Reference Number: 17161

RE: Mayfield West Phase 2 - CaledonTerra - 21T-16007C – Town Comments 2nd Submission

Figure 1: MW2 Framework Plan

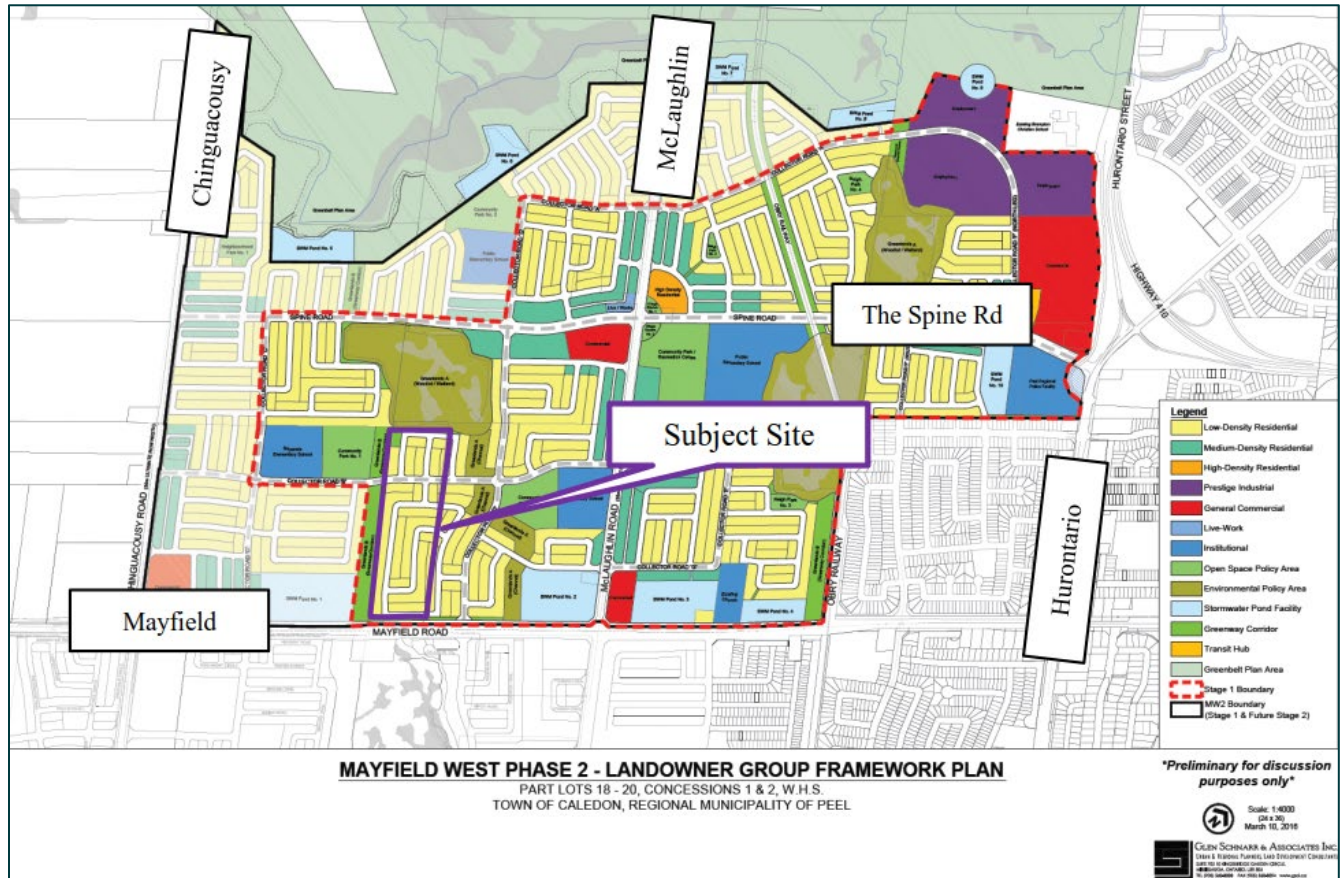
b) Additional discussion/sensitivity analysis on the impacts of the interchange and Mayfield Road Widening should be provided.

This comment has been addressed in the MW2 Phasing Analysis (**Attachment 4**) which was submitted by LEA on August 9th, 2018. The Phasing Analysis was prepared for the entire MW2 development, and represents a more appropriate scale for a discussion for how much Stage 1 development can proceed prior to the Mayfield Road Widening and the Spine Road / Hurontario interchange. As indicated in **Figure 1**, the subject site is located in the south west section of Stage 1, and does not have any direct connection to the Spine Road.

The results indicate that 76% of the Stage 1 development can proceed prior to the Mayfield Road widening, and up to 90% of the Stage 1 development can proceed after the Mayfield Road widening and before construction of the Spine/Hurontario connection. The remaining 10% of Stage 1 is the regional commercial component, which cannot be supported until the Spine/Hurontario connection is completed. Full details of the MW2 Phasing Analysis can be found in **Attachment 4**.

Figure 2: Proposed Speed Bump Locations

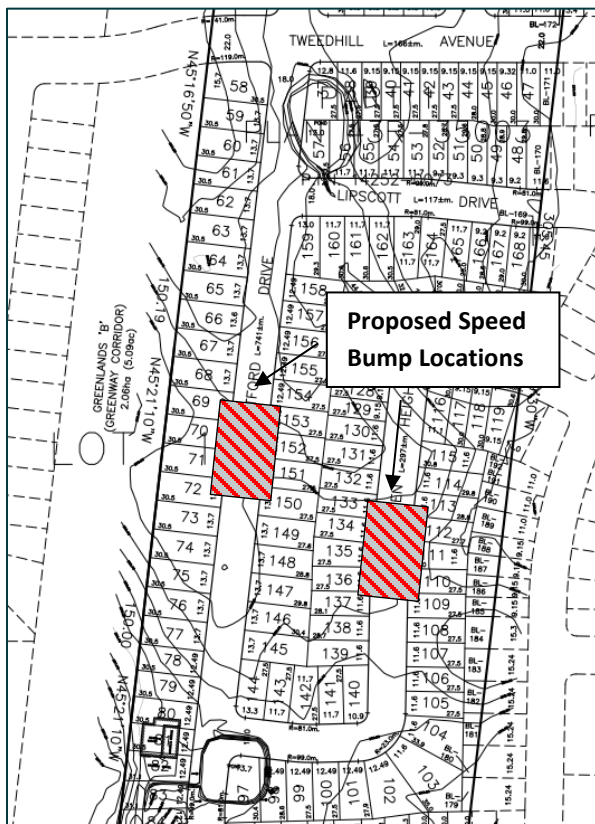
f) Section 4.3, Traffic Calming: Recommended Traffic calming measures are very generic which needs to be more specific for each roadways as per section 7.5 of MW2 Transportation Master Plan.

Based on our review of the latest draft plans for this subdivision (**Attachment 3**), the following traffic calming measures are recommended:

- Given the limited length of Tweedhill Avenue within the Caledon Terra subdivision boundaries, coordinate any recommended traffic calming measures with what is proposed for adjacent draft plans of subdivision to provide a consistent approach.
- Permit on-street parking on all local streets.
- “Traffic Calmed Neighbourhood” signage.
- Implement speed bumps at the following locations to limit the speed of vehicle traffic on local streets. The exact location of these speed bumps will be determined at a later date, but the approximate area is indicated in **Figure 2** below.

Figure 3: Typical Design of Collector Roads w/o On-Street Parking (Source: Figure 6.6a of the CDP)

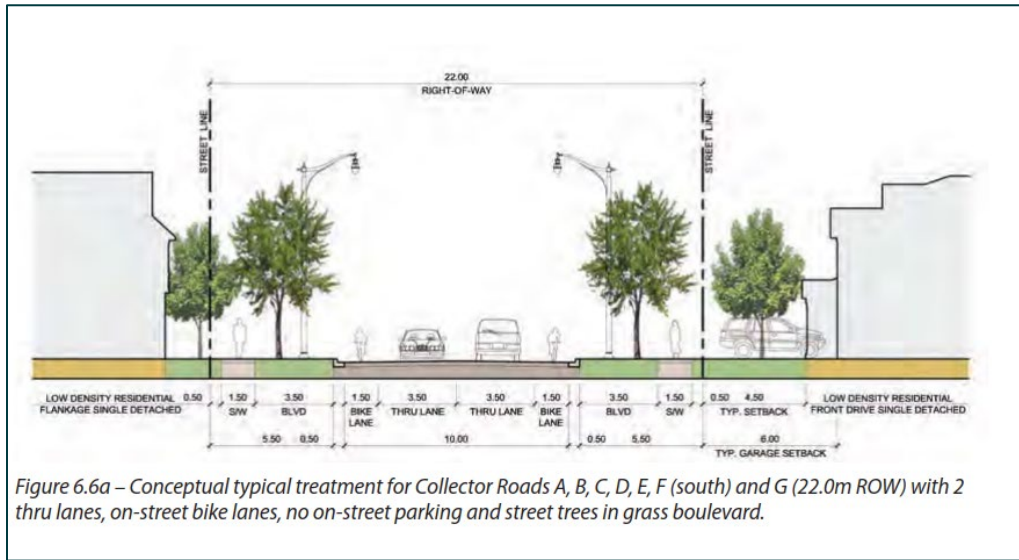
g) Section 5.1, Road Geometry: Additional Commentary on the sidewalk on the collector Roads should be provided.

This commentary pertains to Collector Roads B (Tweedhill Avenue) and D. The CDP typical collector road design without on-street parking is recommended for these roadways, as specified in Figure 6.6a on page 109 of the CDP (see **Figure 3** below). The 22-metre ROW includes 1.5m sidewalks on both sides of the street.
